Administrative Approval Action

Case File / Name: ASR-0076-2022
DSLCL - WEST END II

FINDINGS: City Administration finds that this request, with the below conditions of approval being met, conforms to the Unified Development Ordinance. This approval is based on a preliminary plan dated March 14, 2023 by Mcadams.

2 ROOF TOP VISIBILITY DIAGRAM (CABARRUS ST)
1" = 20'-0"

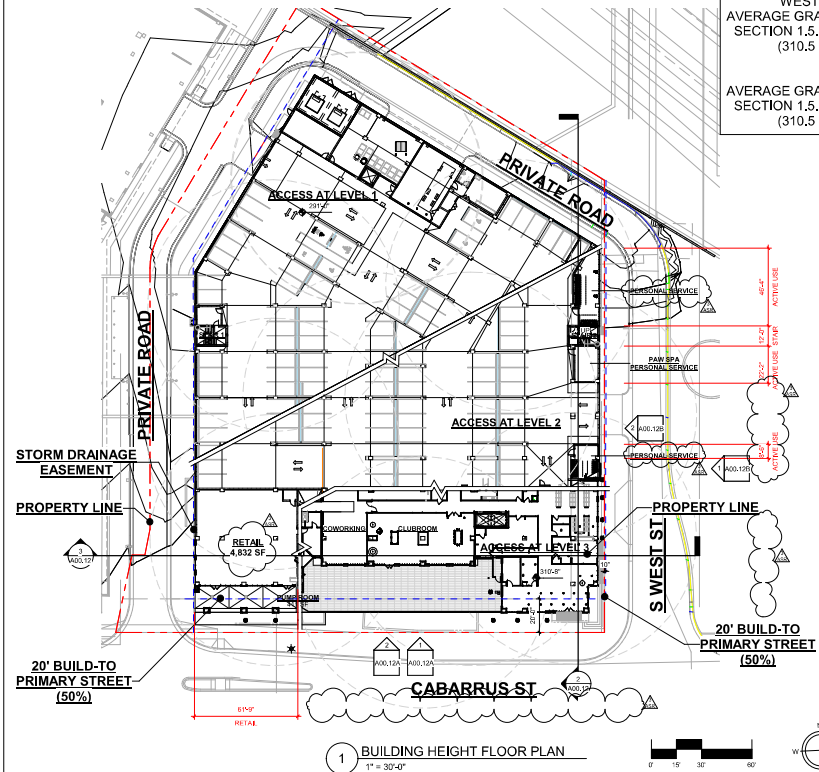
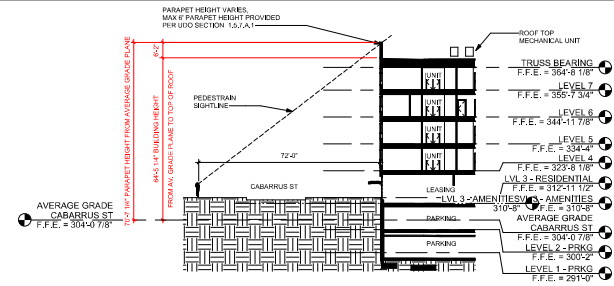
6. Sheets A00.12A, A00.12B, revise all transparency tables, removing/revising the 'provided wall area @ 3'-8"' label references, and label as well provide the "sf area between 3'-8'ft" per the required transparency design requirements in Sec.1.5.9.B.

1 OVERALL BUILDING ELEVATION - SOUTH (CABARRUS ST)
1/8" = 1'-0"

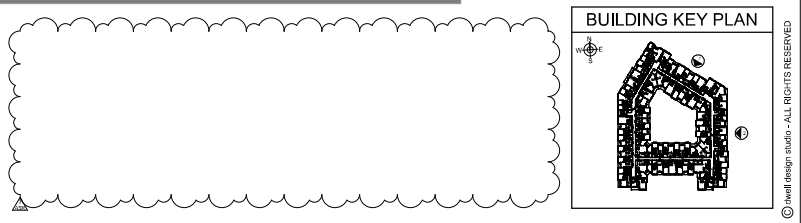
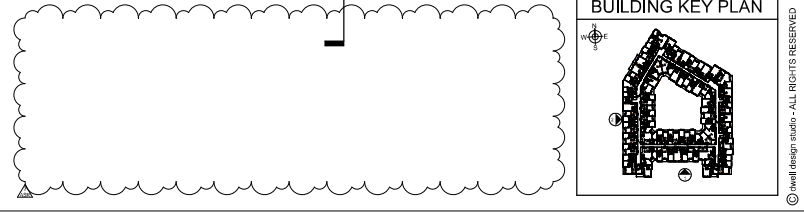
7. Sheets A05.01, A05.02, per the post-development averages shown, a building height dimension is provided and drawn for the east and south façade wall side elevations
